Agenda

REPORT TO DESIGN REVIEW ADVISORY COMMITTEE

AGENDA ITEM
4.A.

SUBJECT: Certificate of Compliance with the Design Guidelines for modifications to the existing structure at 5690 Yukon

1 WEST ELEVATION
SCALE: 3/16" = 1'-0"

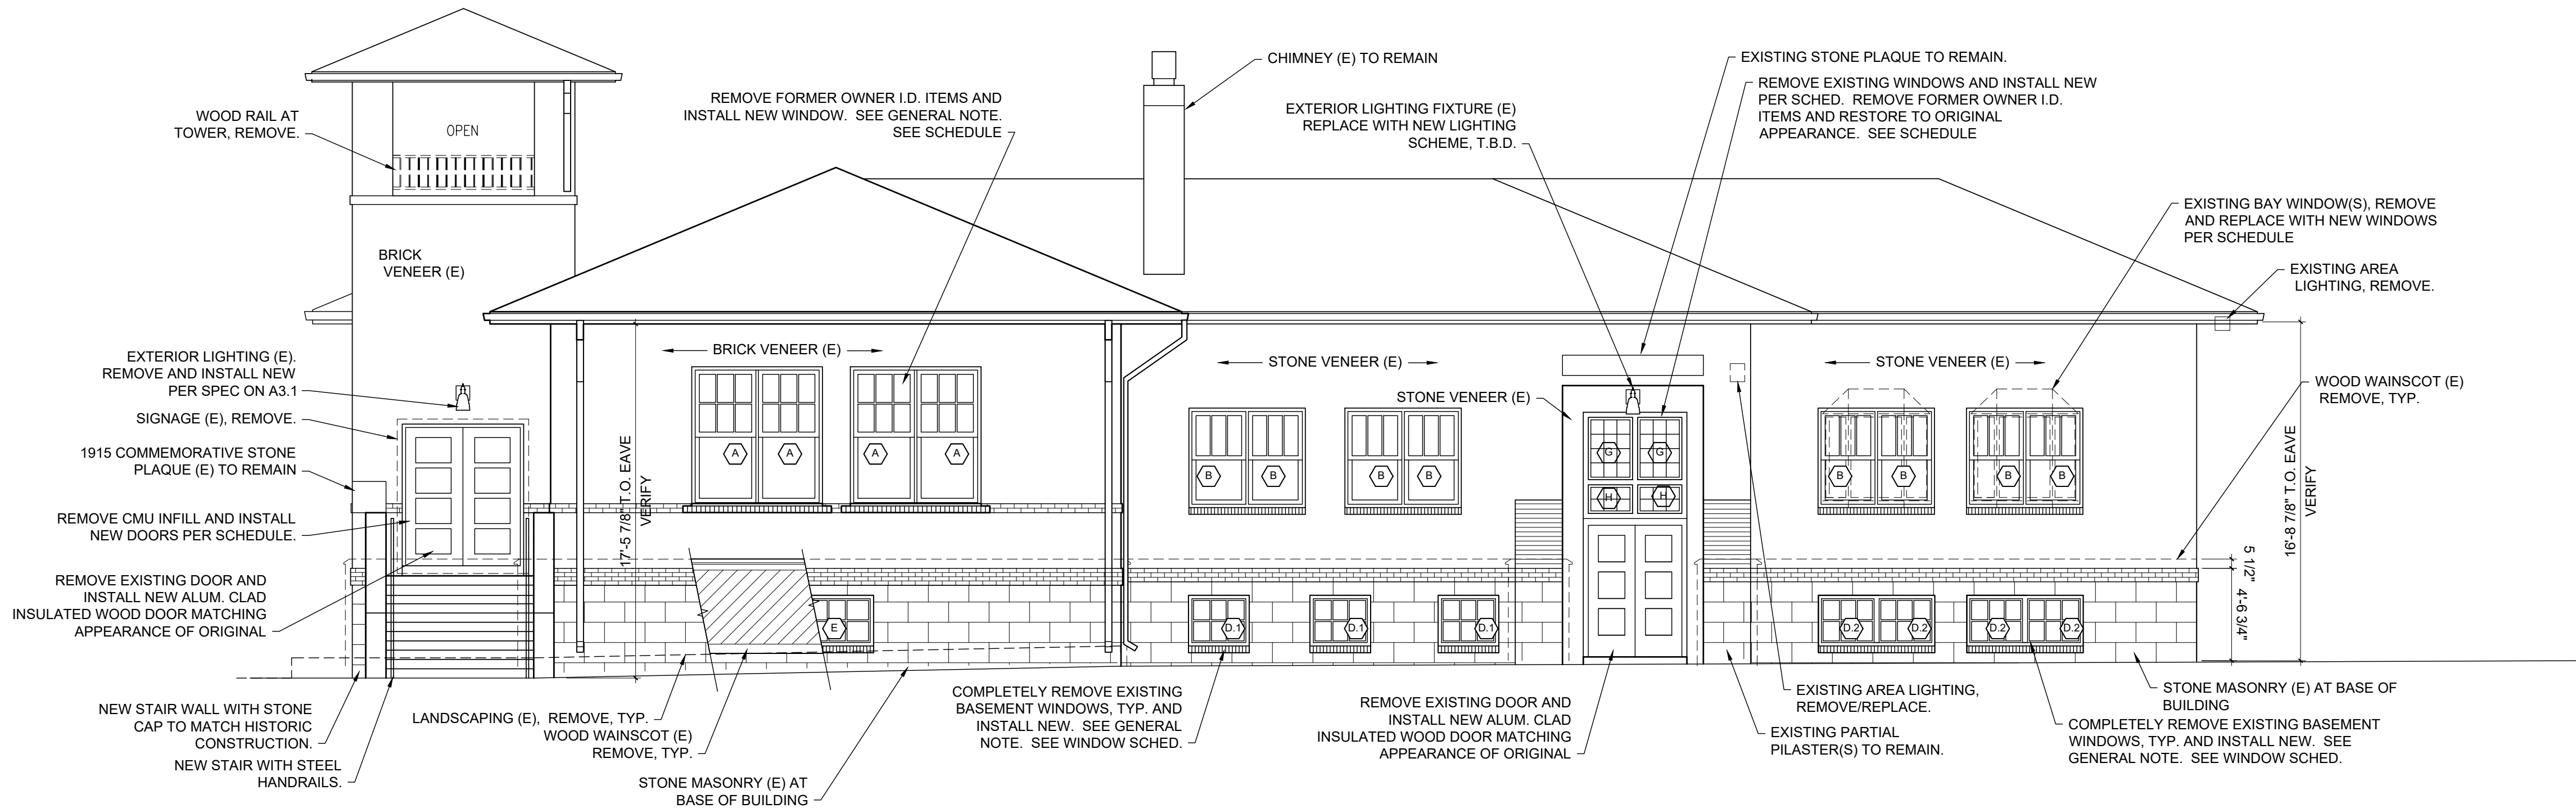
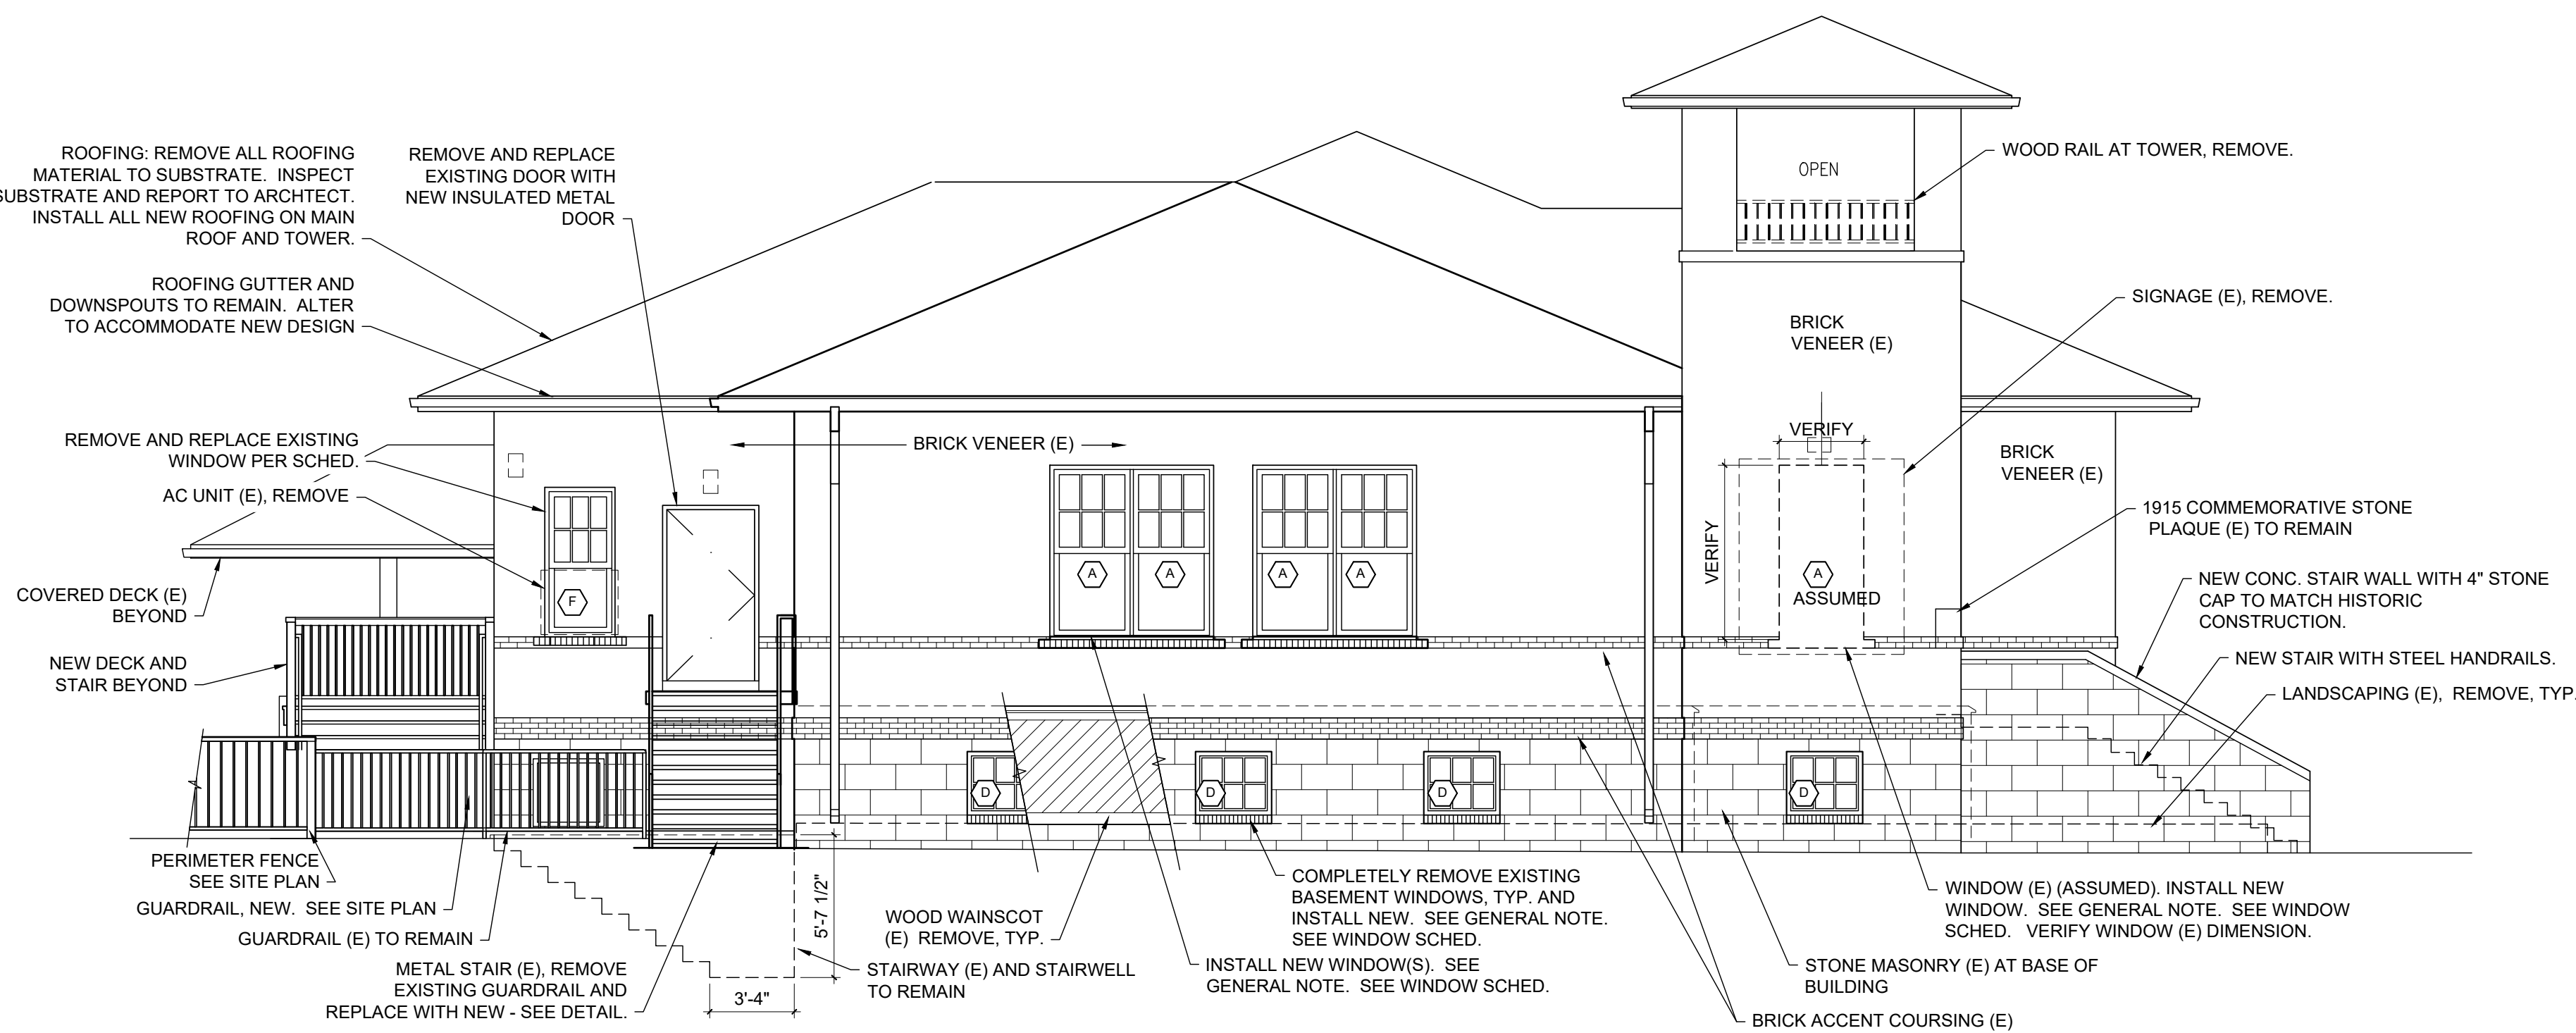
As previously stated, historic photographs were used to select windows that most closely matched the original windows. The window profiles on plan sheet A3.2 depict compliance with this requirement.

The exterior light fixture (see plan sheet A3.1) is fully shielded and is intended to illuminate only the entrances to the building. In addition, it will need to comply with all applicable lighting regulations in the Land Development Code. The light fixture was selected to complement the historic character of the building.
